CITY OF
West Linn

**STAFF REPORT
FOR THE HISTORIC REVIEW BOARD**

FILE NUMBER: DR-23-01

REQUEST: Provide a recommendation to the Planning Commission regarding a proposed Design Exception to exceed the maximum height limit of two stories, as part of a Class II Design Review at 1919 & 1949 Willamette Falls Drive.

4 SECTION | VIEW PROJECTIONS

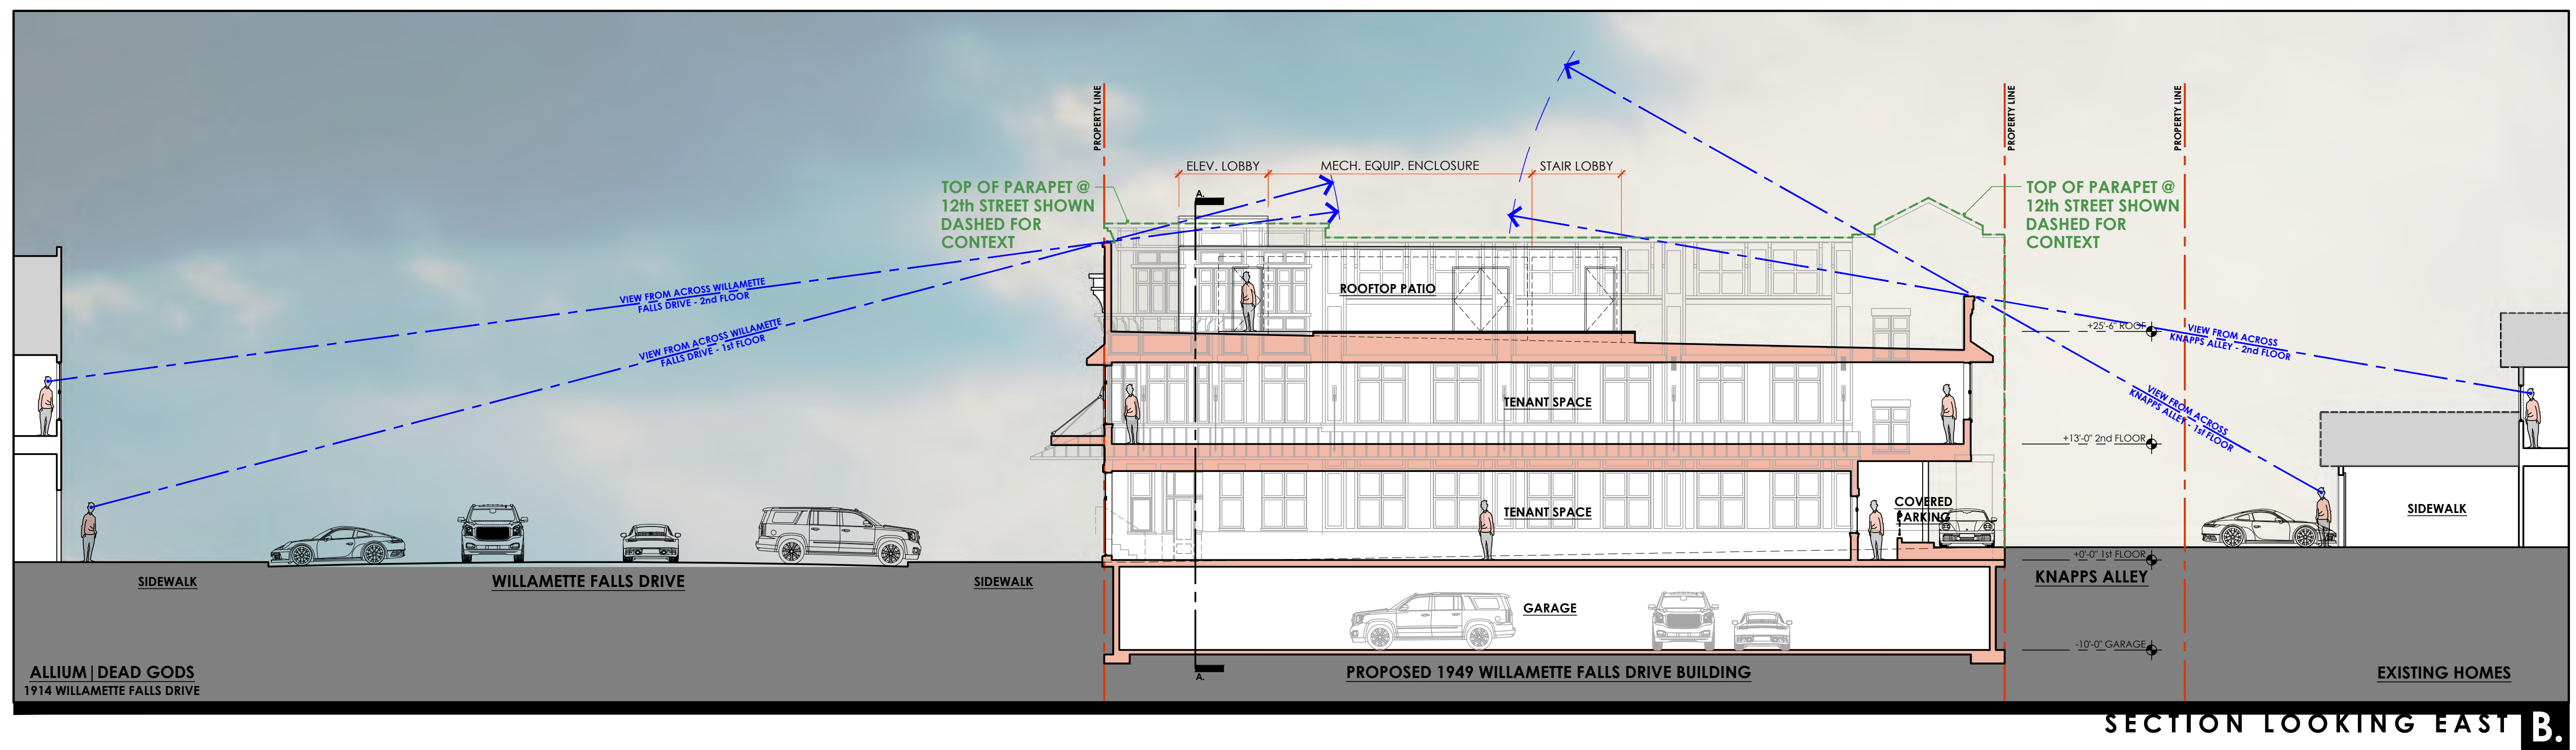
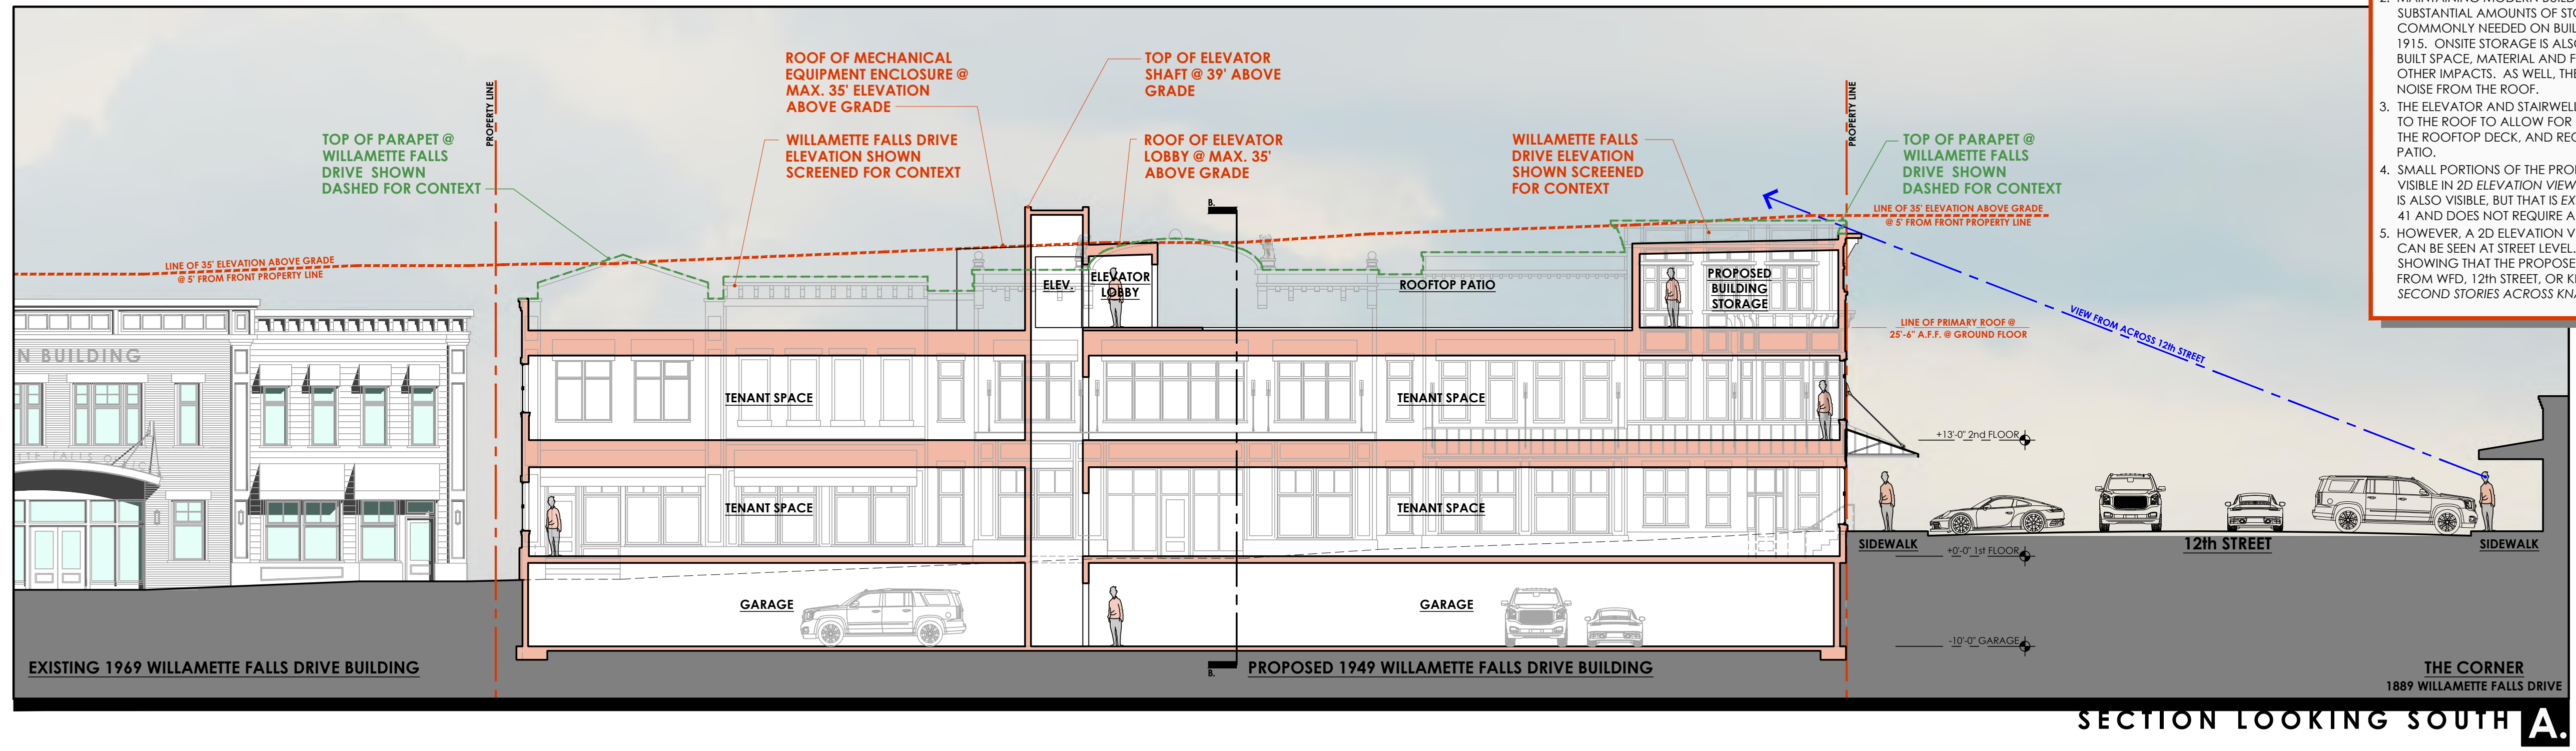
1. WE ARE PROPOSING A DESIGN EXCEPTION TO ALLOW THE TWO ROOF TOP SPACES SHOWN ON THE ROOF PLAN; ONE FOR HOUSING BUILDING HVAC SYSTEMS AND ONE FOR CRITICALLY NEEDED BUILDING STORAGE. THEY SERVE ONLY AS SUPPORT SPACES AND WILL BE UN-OCCUPIED AND UN-CONDITIONED.

2. MAINTAINING MODERN BUILDINGS AND SYSTEMS REQUIRES SUBSTANTIAL AMOUNTS OF STORAGE - LIKELY MORE THAN WAS COMMONLY NEEDED ON BUILDINGS BUILT BETWEEN 1880 AND 1915. ONSITE STORAGE IS ALSO A GREEN ALTERNATIVE, REDUCING BUILT SPACE, MATERIAL AND FUEL CONSUMPTION, TRAFFIC, AND OTHER IMPACTS. AS WELL, THE HVAC ENCLOSURE WILL REDUCE NOISE FROM THE ROOF.
